UNITED STATES PATENT AND TRADEMARK OFFICE

APPLICATION NO.	FILING DATE	FIRST NAMED INVENTOR	ATTORNEY DOCKET NO.	CONFIRMATION NO.
10/807,000	03/23/2004	Ki-Chul Kim	5649-1266	2826

Office Action Summary	Application No. 10/807,000	Applicant(s) KIM ET AL.	
	Examiner Thinh T. Nguyen	Art Unit 2818

DETAILED OFFICE ACTION

FIG. 9

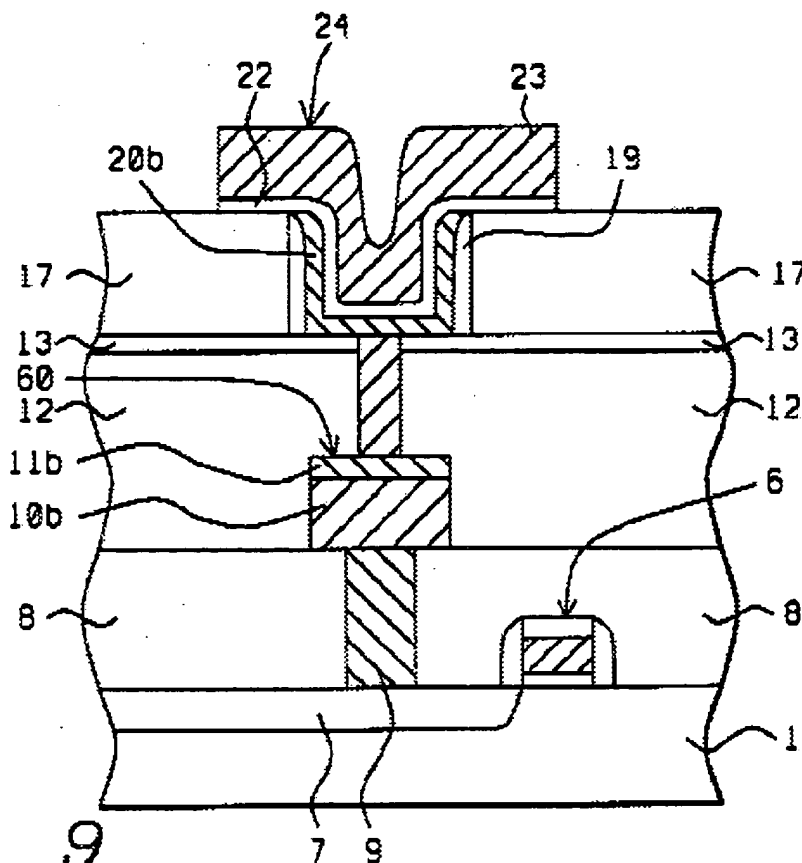
Lou (fig 9 ,column 4 line 21-22) discloses an integrated circuit comprising: a microelectronic substrate; a dielectric layer on the substrate; a conductive contact plug (fig 9 reference 9) extending through an opening in the dielectric layer to contact the substrate and including a widened pad (fig 9 reference 60) portion extending onto the dielectric layer adjacent the opening; an ohmic pattern on the pad portion of the plug; (fig 9 reference 10b) this layer is made of tungsten, a barrier pattern on the ohmic pattern (fig 9 reference 11b) made of ruthenium ; a concave first capacitor electrode disposed (fig 9 layer 20b) on the barrier pattern and defining a cavity opening away from the substrate; a capacitor dielectric layer (fig 9 layer 22) conforming to a surface of the first capacitor electrode; and a second capacitor electrode (fig 9 layer 23) disposed on the capacitor dielectric layer opposite the first capacitor electrode.

Lou (fig 9 ,column 4 line 21-22) discloses an integrated circuit device comprising: a microelectronic substrate; a dielectric layer on the substrate; a conductive contact plug extending (fig 9 reference 9) through an opening in the dielectric layer to contact the substrate and including a widened pad portion(fig 9 reference 60) extending onto the dielectric layer adjacent the opening; stacked ohmic (fig 9 reference 10b) and barrier patterns (fig 9 reference 11b) disposed on the pad portion of the plug and having sidewalls substantially coplanar with a sidewall of the pad portion; a first capacitor electrode (fig 9 layer 20b) disposed on the barrier pattern; a capacitor dielectric layer (fig 9 layer 22) on the first capacitor electrode; and a

second capacitor electrode (fig 9 layer 23) on the capacitor dielectric layer opposite the first capacitor electrode.

Lou discloses (in fig 9) support layer 12.

FIG.9

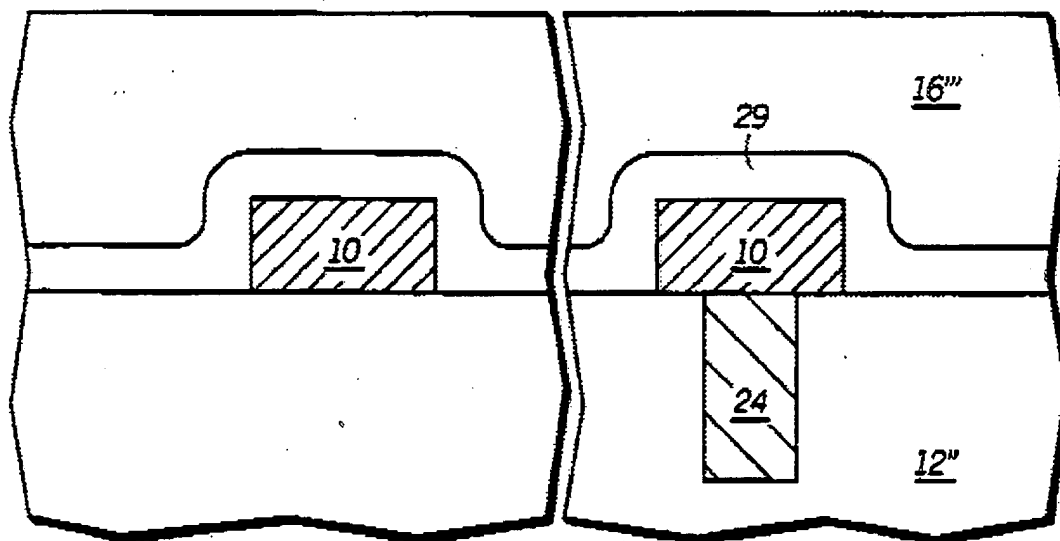
Lou discloses all the inventions of claims 3-6,14-17 except for the use of a conformal etch stop layer; this feature, however, is considered obvious since it is old and well known in the art (as shown by the disclosure by Woo et al. US patent 5,451,543 claim 4 and fig 9 conformal etch stop layer 29) a person skilled in the art at the time the invention was made would have been capable from using the teachings by Lou and his ordinary design skill and come up with the invention of claims 3-6 without any special instructions.

FIG. 4

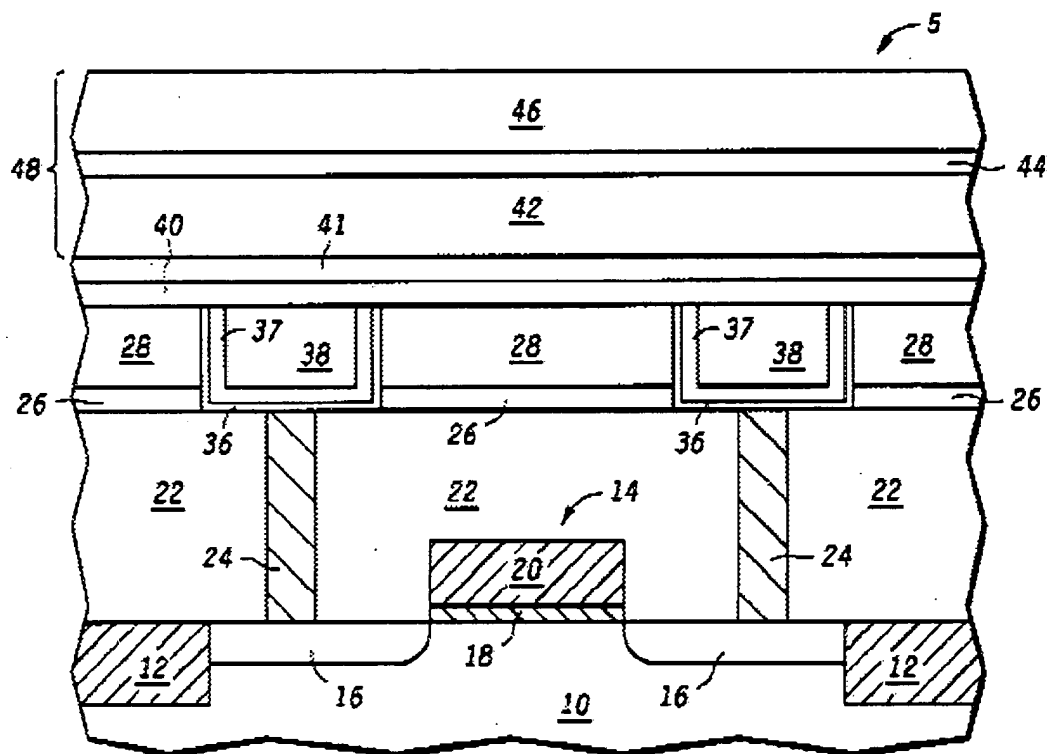
Lou discloses all the inventions except for the use of Titanium nitride, Tantalum nitride etc as barrier layer; this feature, however, is considered obvious since the use of titanium nitride or tantalum nitride as barrier layer are old and well known in the art as shown in the disclosure by Islam et al. (US patent 6,174,810), fig 4 barrier layer 36.
